**MARYLAND DEPARTMENT OF THE ENVIRONMENT
AIR AND RADIATION ADMINISTRATION**

**FINAL DETERMINATION CONCERNING A
PERMIT-TO-CONSTRUCT, PSD APPROVAL, AND NSR APPROVAL APPLICATION
SUBMITTED BY US WIND, INC. FOR THE CONSTRUCTION AND COMMISSIONING
OF THE MARYLAND WIND OFFSHORE PROJECT**

**MARYLAND DEPARTMENT OF THE ENVIRONMENT
AIR AND RADIATION ADMINISTRATION
RESPONSE TO COMMENTS
FOR THE
US WIND INC. - MARYLAND OFFSHORE WIND PROJECT
APPROXIMATELY 10 NAUTICAL MILES OFF THE COAST OF
WORCESTER COUNTY, MARYLAND**

Observed Wind Data – Ocean City Airport

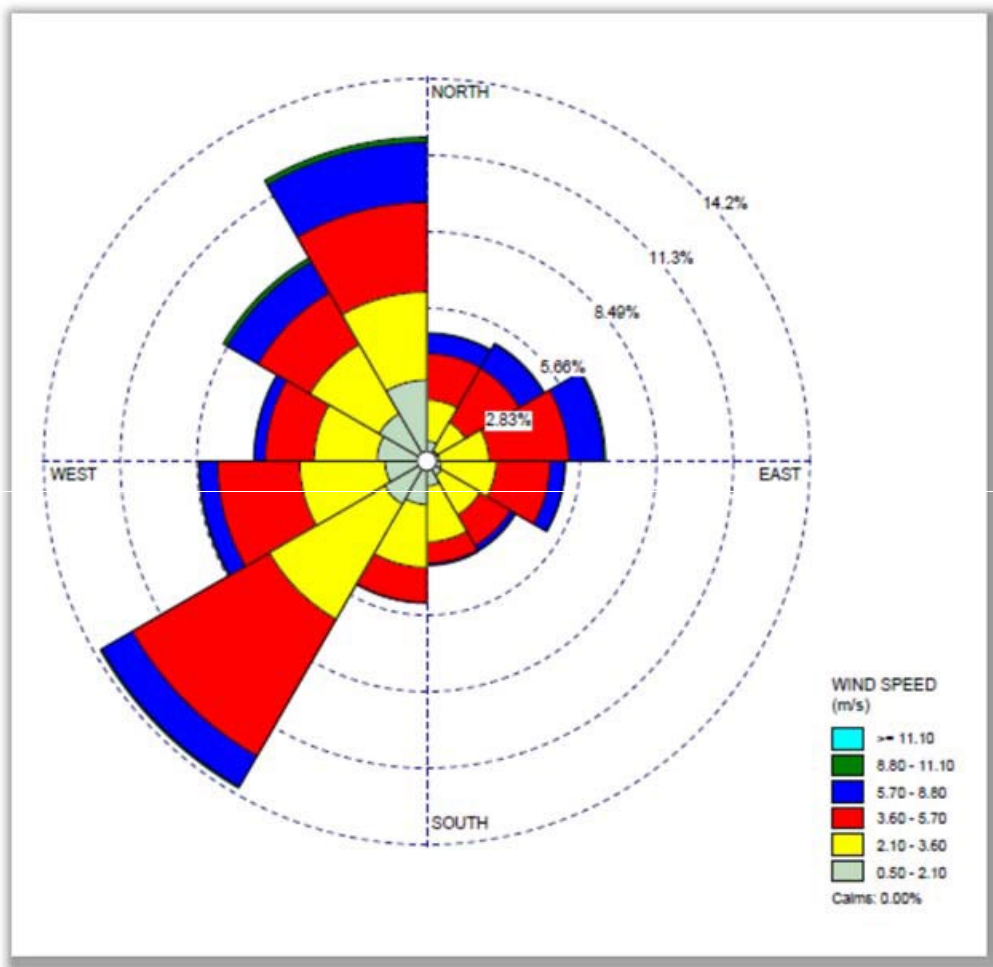
Comments related to the potential significant impact of the wake effect from the offshore wind turbines. A commenter asked, "if a permit can be denied only based on the potential impact of this effect." There have been some concerns on how the potential wake effect may also impact or increase ozone levels.

Another commenter shared concerns related to the potential impact that wind turbines could have due to the potential increase in the ozone layer in nearby urban areas.

Wake effect" refers to the phenomenon downstream from a wind energy facility, which results from the changes in wind speed caused by the impact of turbines on each other. When wind passes through a turbine, the blades extract energy from the wind, which reduces the wind speed and changes its direction in the area immediately downstream of the turbine, creating a "wake" region characterized by reduced wind speed and turbulence.

Wind turbine wake effects would have minimal to no impact on the ozone (O₃) levels along Maryland's coastline, or near more local areas (i.e., Ocean City) and inland areas in nearby counties on the Eastern shore. The wind farm (turbines) will be operating at a distance of approximately 10.0 nautical miles (~18.5 km, 11.5 miles) offshore from the nearest shoreline.

Near Ocean City, the wind generally blows from the northwest toward the southeast or from the southwest toward the northeast. This is documented in the wind rose created using wind speed and direction collected at Ocean City Airport (taken from Appendix B – Meteorological Data Evaluation, US Wind – Maryland Offshore Wind Project Air Quality Modeling Protocol).

Since the wind near Ocean City is generally moving off-shore, and because the wake effect is felt in the same direction as the wind is blowing but after (i.e. behind) the wind turbine, the wake of the wind turbine generators would generally be moving toward the open ocean. Figure 1-2 in the permit application shows the location of the wind farm in relation to the coastline. Based on the prevailing wind, the wakes of the wind turbine generators will predominantly be on the east, or the northeast side of the wind farm on the open ocean side, not toward the coastline.
